STAFF REPORT: 12/13/2023 MEETING
APPLICATION NUMBER: HDC2023-00145

ADDRESS: 4138 LINCOLN

HISTORIC DISTRICT: WOODBRIDGE FARM

SCOPE OF WORK: REPLACE WINDOWS; CONSTRUCT PORCH

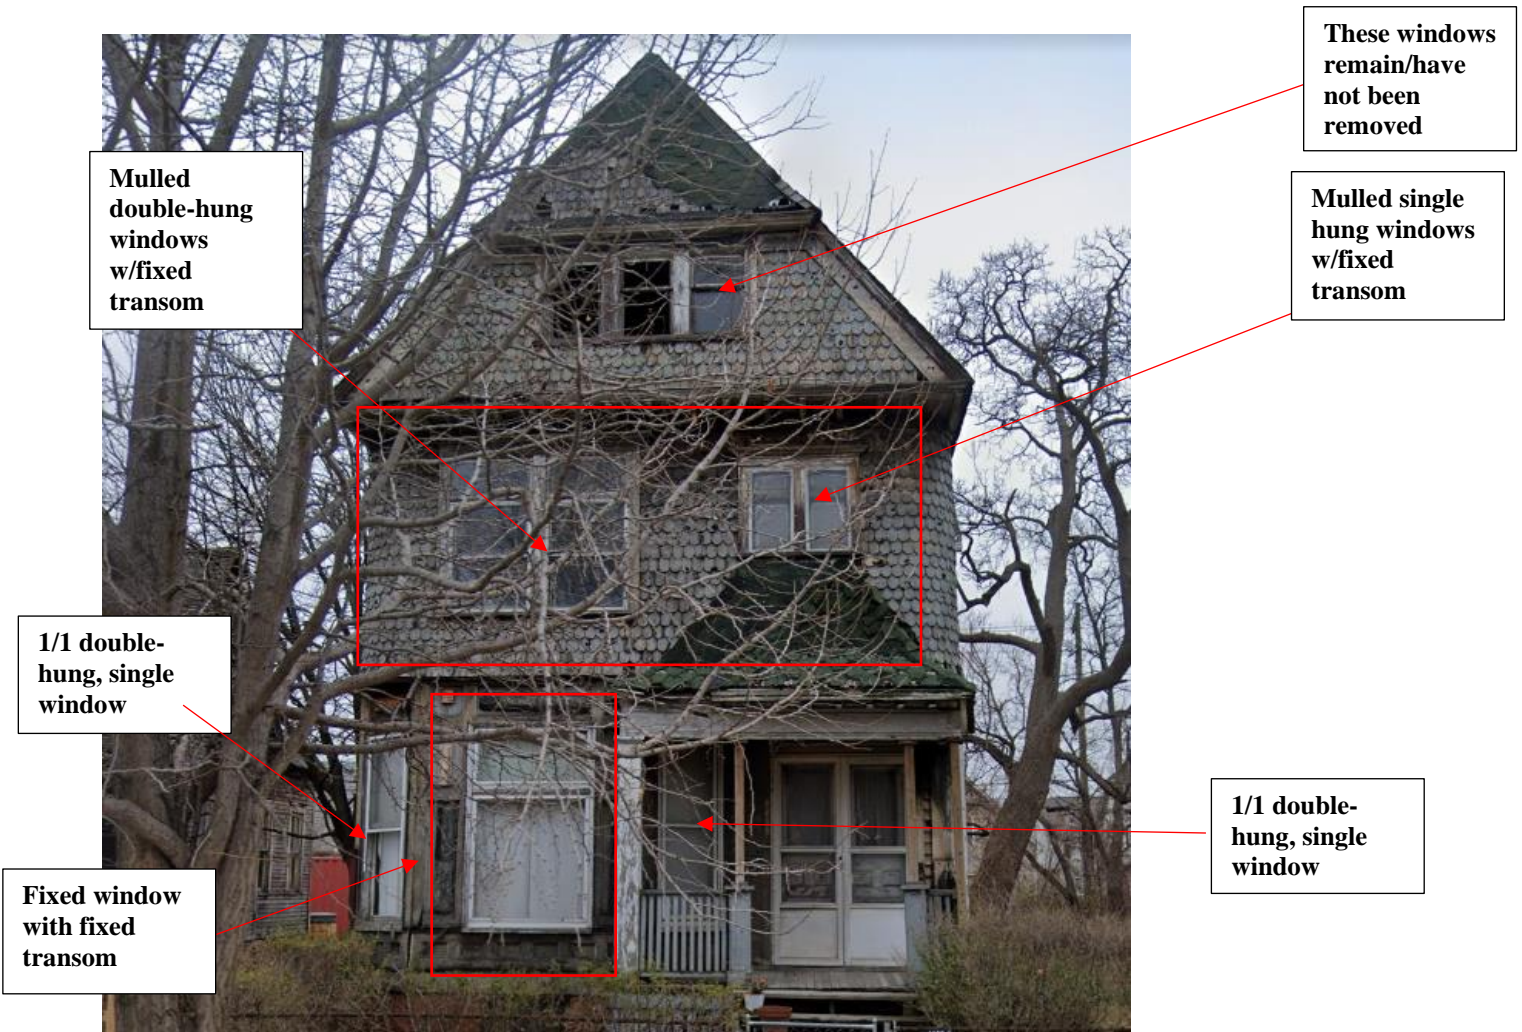
However, note that the current application does not include the dimension details for the **five historic windows at the front façade which include transoms** because they were removed and disposed of without first documenting them, as previously noted. The project architect stated that they estimated the dimensions of these windows based upon an examination of the 2021 photos.

- ⊖ A review of the documentation indicates that the Marvin Ultimate wood units proposed for installation in the current application (as well as the Marvin Ultimate aluminum clad wood units proposed in the property owner’s 9/13/2023 application) generally meet the threshold to be considered an adequate replacement product for an historic window *that has been determined to be deteriorated beyond repair/demonstrates diminished integrity* or for installation in a new window opening. However, such manufactured units are not an exact replication or restoration of the historic, character-defining windows that were removed without HDC approval and could have been repaired. Per previous Commission discussion, a custom build is the only means to achieve an exact replication of these units and appropriately restore the property’s lost historic character. Staff therefore recommends that the Commission deny the proposal to install new Marwin wood windows at the front façade and north wall.

- The original wood windows at the north/side wall and front/west façade were distinctive, character-defining features of the home and were in repairable condition in 2021. As no documentation exists to demonstrate that these windows were deteriorated beyond repair at the time of their removal, an exact replication of these units is the appropriate treatment.

Renderings of new side elevation porch design which denied by the HDC at the 9/13/2023 meeting (below)

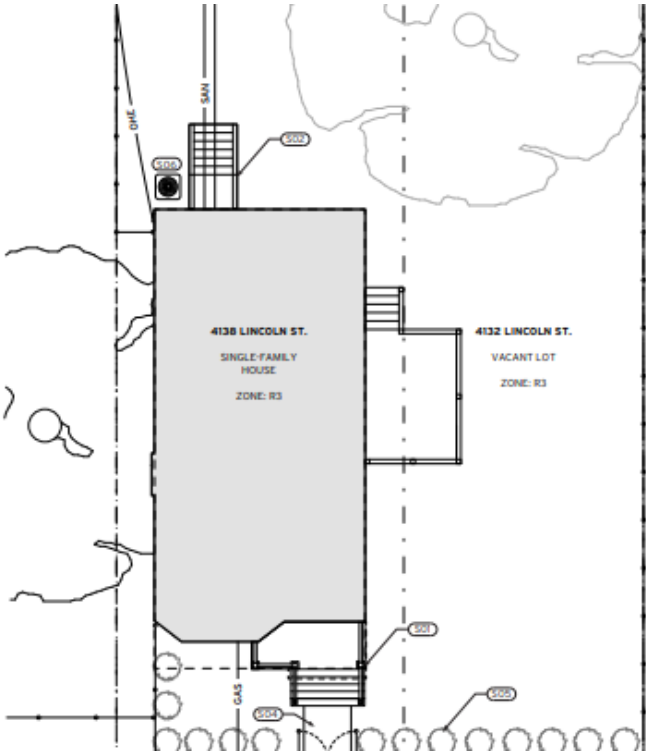
- Note that the applicant's 9/13/2023 application to the Commission proposed to install a new wood porch deck at the building's south wall (see below). The Commission denied this work item for the following reasons:
 - The scale/footprint of the proposed new side elevation deck was too large/wide as it extended into the adjacent lot at 4132 Lincoln. A porch at that location would have been designed to fit within the boundaries of the parcel which the house sits.
 - Re: the proposed new deck, the south side wall is highly visible from the public right-of-way as an adjacent parcel is vacant.
 - Historically, wood porches typically included a roof overhang of some kind in order to protect the floor from deterioration due to exposure to weather.

The applicant has therefore revised the porch design to reduce the size of the porch's footprint. A hipped roof has been included with the new design (see below/next pages).

Current/revise renderings depicting design for new side elevation porch (below)

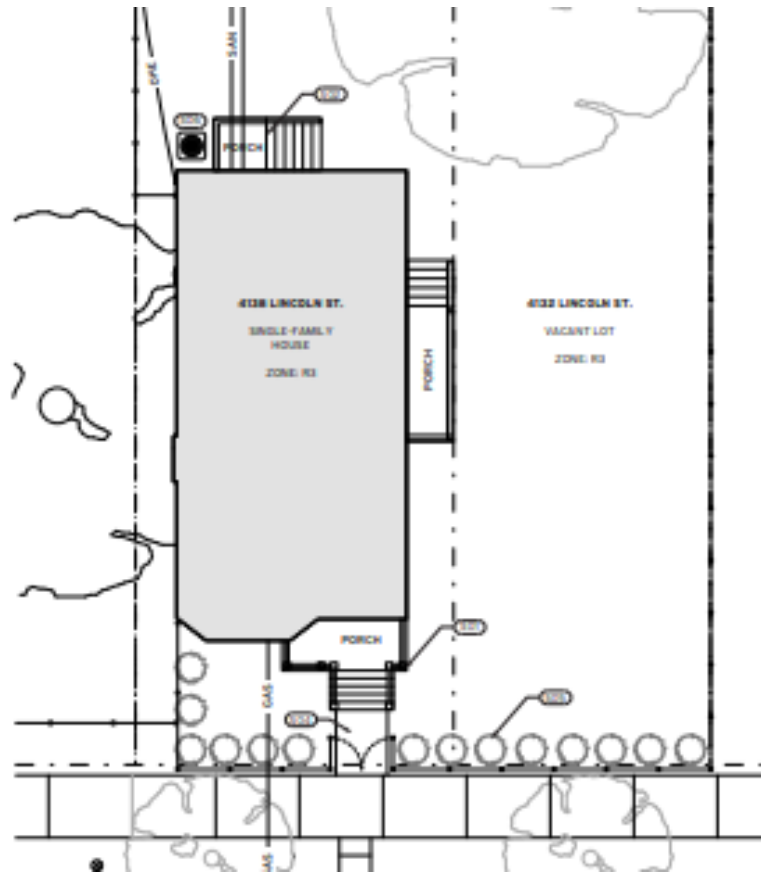
- The size, scale of mass, materials, relationship of solids to voids, and color of the proposed new porch design is generally compatible with the existing historic building. However, staff does note that the hipped roof proposed for the new side porch appears too flat/shallow when compared to the roof at the existing/historic front façade porch. Staff recommends that the height of side porch’s roof pitch be raised slightly so that that it more closely resembles the appearance of the front porch roof, without necessarily duplicating it.

- Generally speaking, the proposed new porch will not obscure, damage, or destroy character-defining features at the property. However, note that the applicant proposes to remove the historic wood brackets which are currently located at the underside of the second story bay and install them at the new porch soffit (see below). Although these brackets are currently not easily visible from public right of way, staff does recommend against this aspect of the proposal as it will destroy the historic relationship between the bay and its original decorative detailing. The brackets should be preserved and rehabilitated in their historic position, allowing the original architecture of the building to be readable in the context of the new porch.

- A review of the submitted drawings reveal that the proposed new side porch is not documented to the same level as the work proposed for the existing front porch/to an extent that staff is fully clear of the side porch’s final appearance. Staff therefore recommends that the applicant provide dimensional design drawings at a 5/8” scale or better for the new porch for review and approval prior to issuance of the project permit.

- The pitch/hip height of side porch's roof shall be raised so that that it more closely resembles the appearance of the front porch roof.
- The existing brackets at the underside of the south elevation's second story bay shall be repaired and remain in place/shall not be installed at the new porch roof.
- The applicant shall submit revised dimensional design drawings of the new south side porch at a 5/8" scale or better to HDC staff reflecting these conditions for review and approval prior to the issuance of the project permit.

Current/ revised site plan depicting design for new side elevation porch (below)

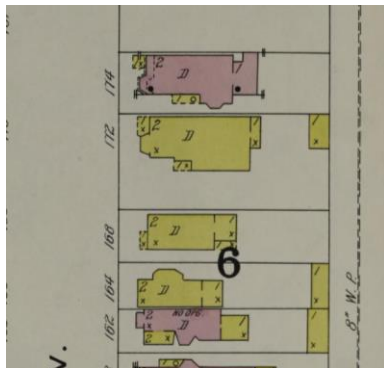
- The new porch will be visible from the public right-of-way because the lot directly to the south of the property is vacant. However, historically this was an area of less visibility as a two-story home had been extant in the adjacent lot to the south as early as 1897 per the below Sanborn maps.

- The porch will be located within the property's boundaries/will not extend into the adjacent lot
- The porch is located towards the rear of the wall
